WOLF CREEK

NUCLEAR OPERATING CORPORATION

March 8, 1996

Subject: Docket No. 50-482: Revision to Technical Specifications
to Implement Cycle 9 Reactor Coolant System Thermal
Design Flow Reduction

Figure 1 : Core Thermal Limit Protection

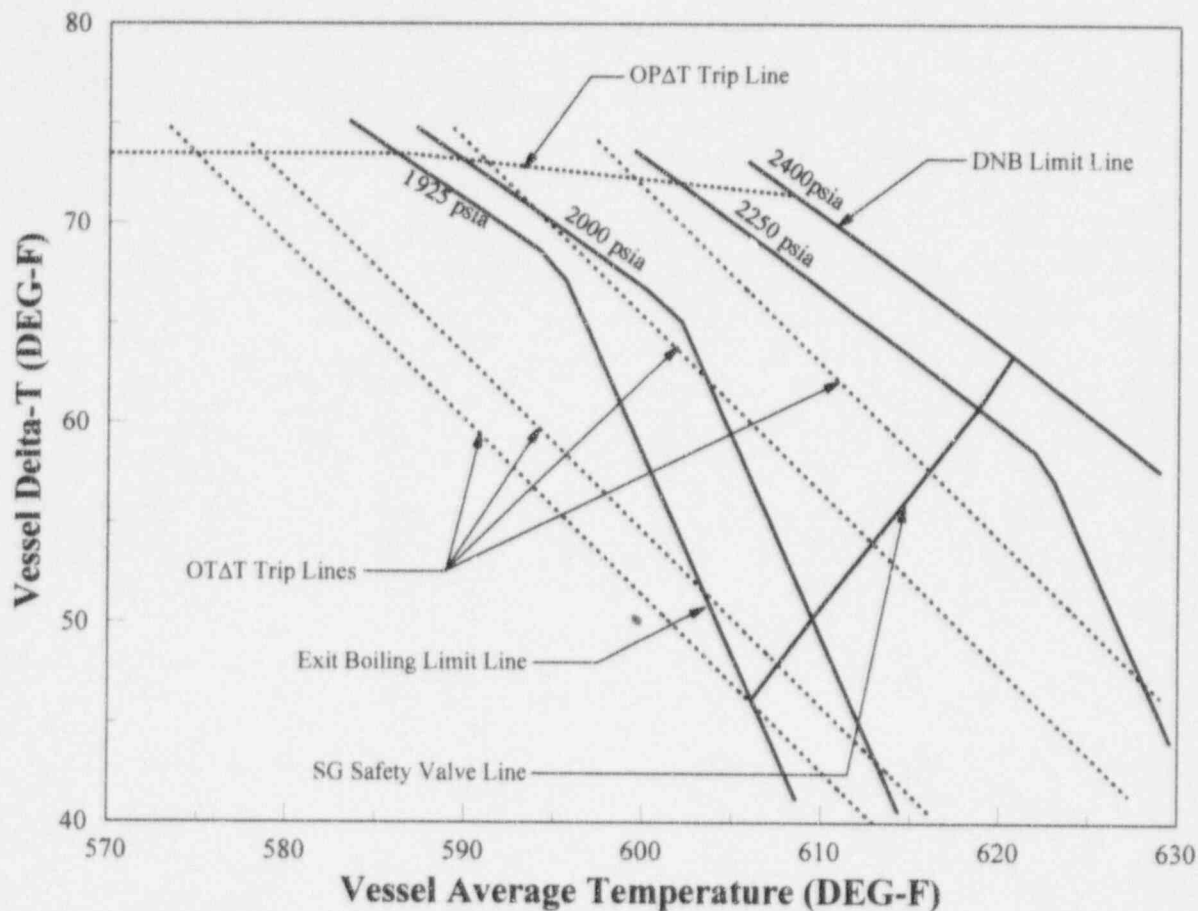
Protection of the core thermal limits is illustrated in the WCGS USAR Figure 15.0-1 and is provided in Figure 1 below. The figure demonstrates that the OTAT and OPAT protection system setpoints and the steam generator safety valves prevent violation of the vessel exit boiling limits, Departure from Nucleate Boiling Ratio (DNBR) correlation exit quality limit, and DNB limits for a range of pressurizer pressures which bound allowable operating space. This range is defined by the Low and High Pressurizer Pressure trip setpoints.

Changes in the primary side parameters associated with the reduction in thermal design flow affect the core thermal limit calculations. The reduction in flow penalizes the calculated limits, restricting the range of allowable operating space. Thus, the core thermal limits have been revised to account for the reduction in design flow.

The vessel exit boiling limit lines are a family of curves which represent the locus of points at which the vessel exit enthalpy is equal to the saturation enthalpy at the applicable system pressure. While the vessel exit boiling limits do not serve a direct function in core protection, it is necessary to limit the vessel exit enthalpy to a subcooled state, since many of the reactor protection system functions use vessel ΔT as indicator of core power. The inherent assumption in these protection system functions is that vessel ΔT is proportional to core power; a valid assumption as long as the coolant remains subcooled. Thus, to guarantee that vessel ΔT remains proportional to power, the core exit enthalpy is restricted such that exit boiling will not occur.

The core DNE limit lines are lines of constant DNBR below which there is a 95% probability at the 95% confidence level that DNB will not occur during normal operation, operational events, or as a result of conditions arising from any fault of moderate frequency. The reduction in thermal design flow results in

restrictions on allowable operating space. However, examination of the OTAT and OPAT trip functions indicate that these restrictions are bounded.

An additional effect of the reduction in thermal design flow is a change in the location of the steam generator safety valve line resulting from the changes in secondary side parameters. This line, which represents the locus of conditions under which the steam generator safety valves open, shifts such that a broader range of attainable operating conditions exist. Initial evaluation of the core thermal limit protection with the revised position of the steam generator safety valve limit line indicated violations in the Vessel exit boiling limits for low values of system pressure. Restricting the allowable pressure range at the low end produces margin to the corresponding pressure OTAT trip setpoint conditions. The low end of the allowable system pressure range is defined by the Low Pressurizer Pressure trip setpoint. The system pressure range was therefore shortened by increasing this setpoint. An increase in the Low Pressurizer Pressure trip setpoint safety analysis limit from the current value of 1915 psig to 1940 psig ensures that the revised Vessel exit boiling limits are protected by the existing OTAT trip setpoint safety analysis limit and the revised steam generator safety valve limit lines.
